**STAFF REPORT 10-13-2021 REGULAR MEETING**

**APPLICATION NUMBER: 21-7512**

**ADDRESS: 1091 SEMINOLE STREET**

**SCOPE: DEMOLISH EXISTING REAR SIDE PORCH AND ERECT NEW REAR SIDE PORCH; MODIFY EXISTING REAR ADDITION**

2 EXTERIOR ELEVATION - EXISTING  
SCALE: NTS

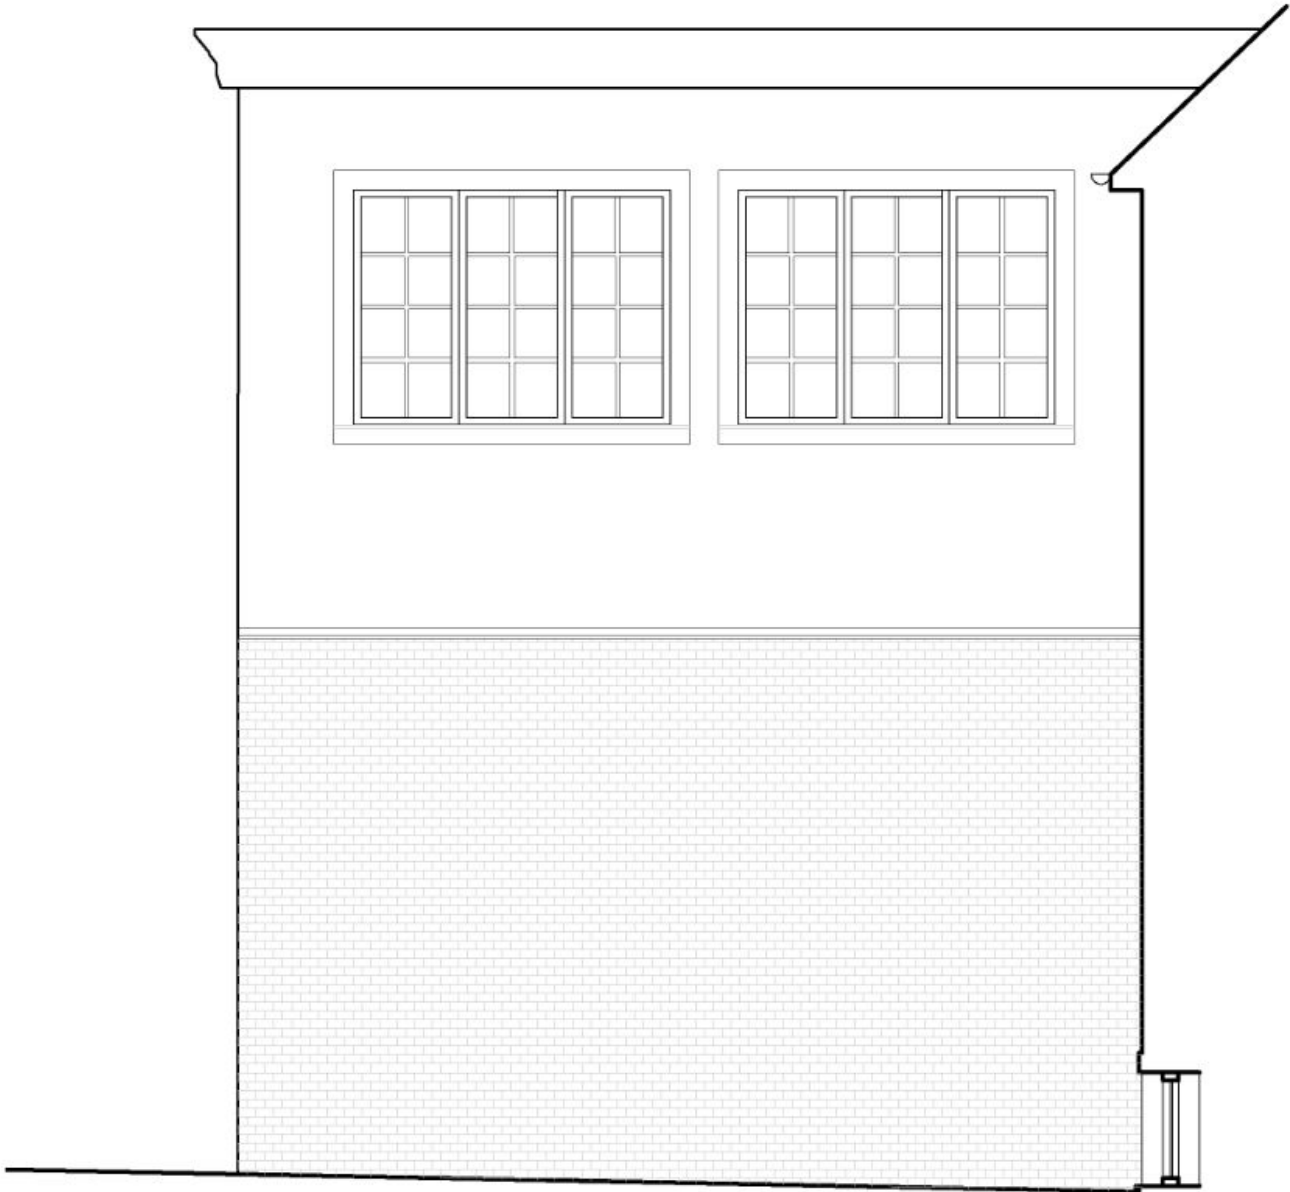
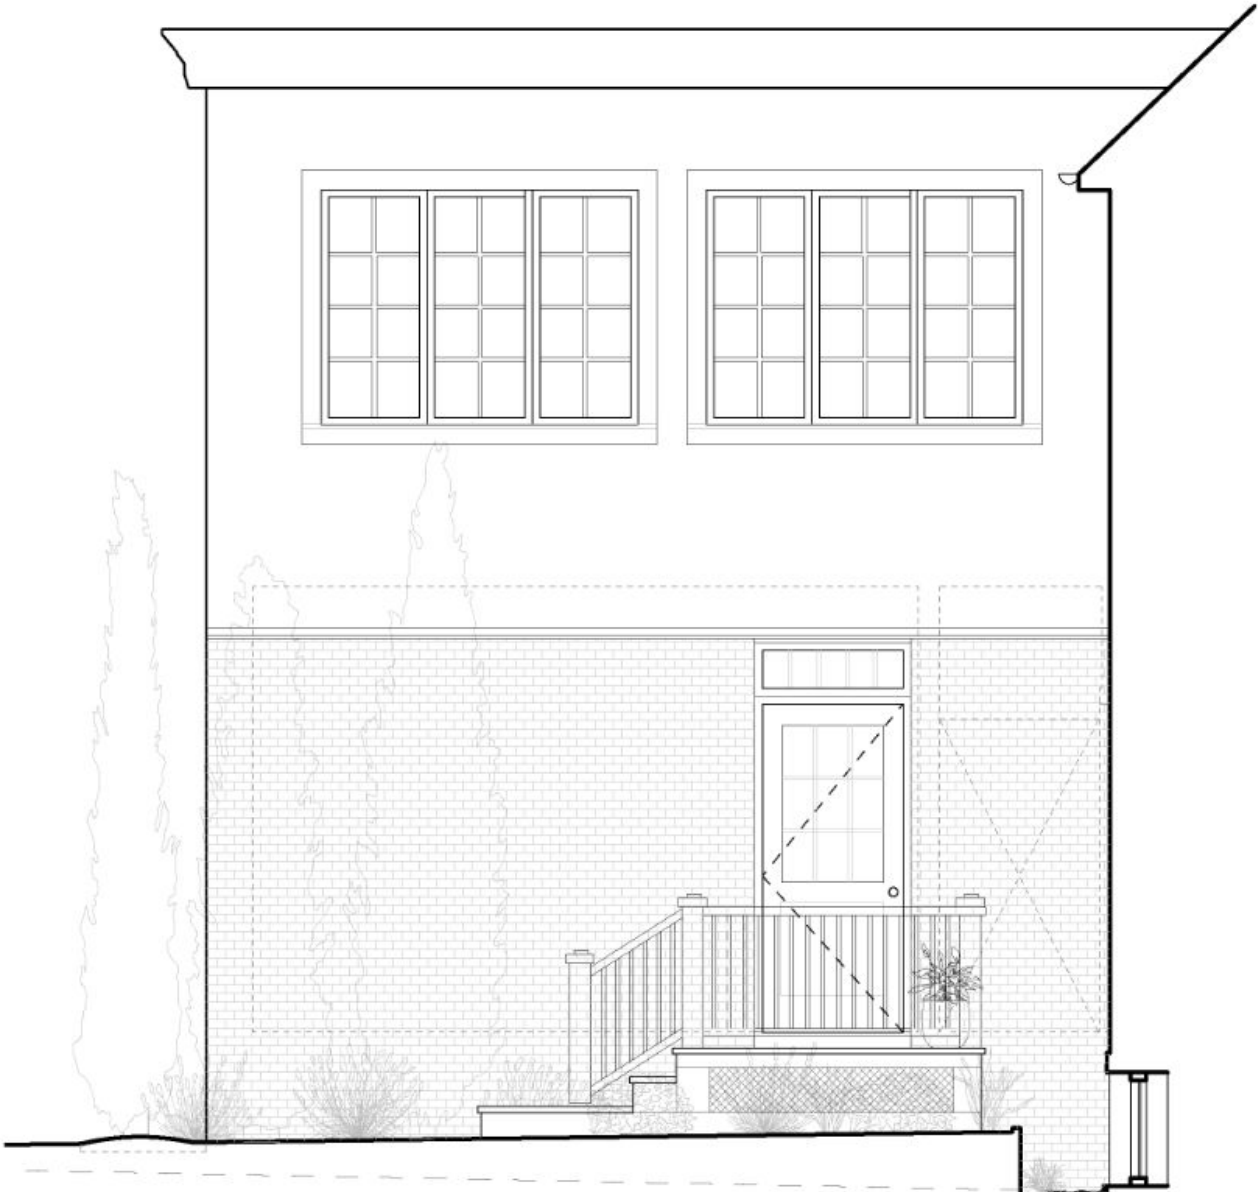
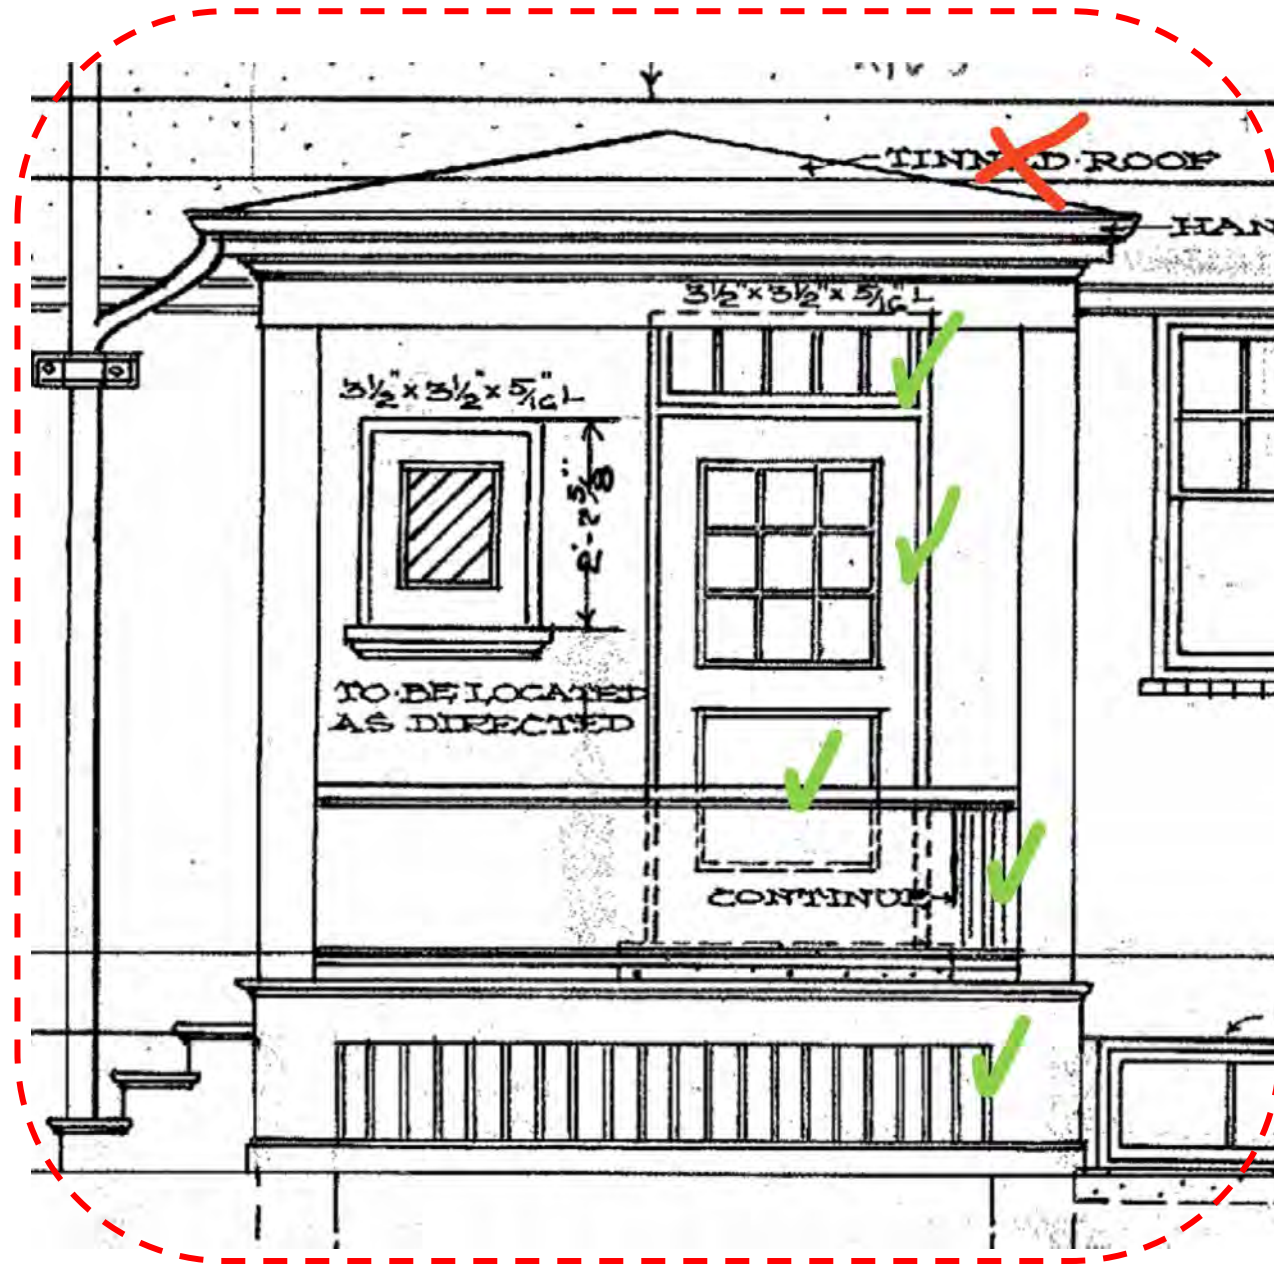
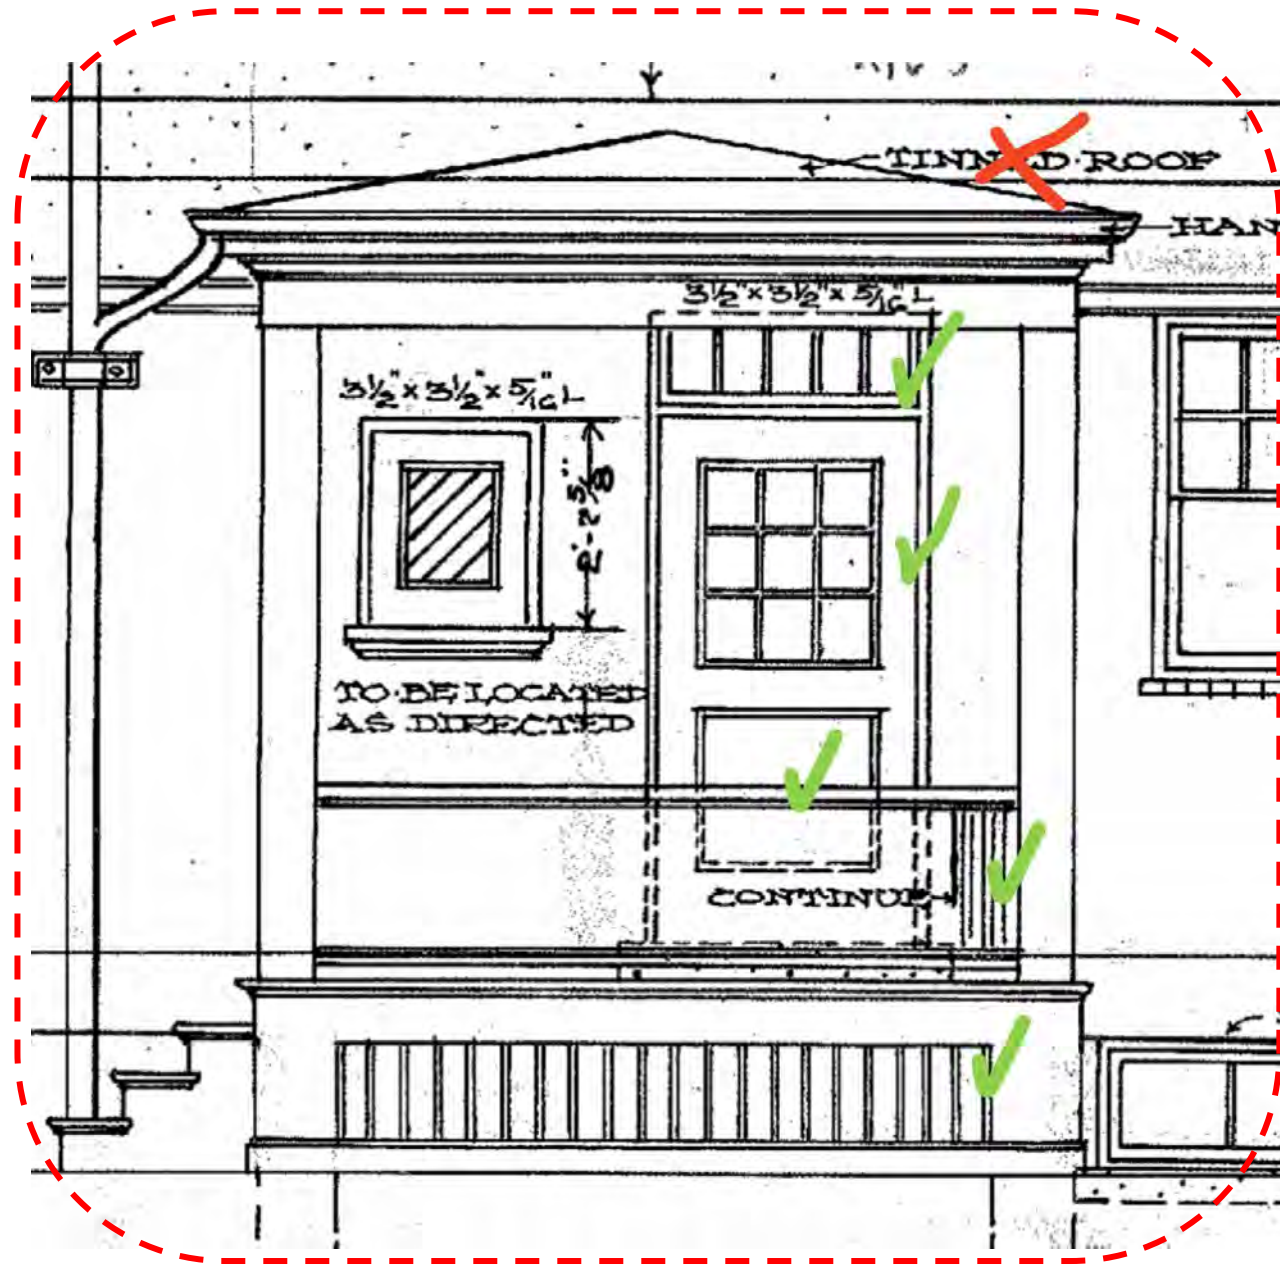
It is staff's opinion that the proposal to create a new masonry opening for a new door and transom at the south wall of the existing north addition and the erection of a new small porch with stairs to access the rear yard at that location, as proposed should qualify for a Certificate of Appropriateness. Staff recommends that the Commission approve a COA for the proposed application, as it meets the Secretary of the Interior's Standards and the Indian Village Elements of Design.
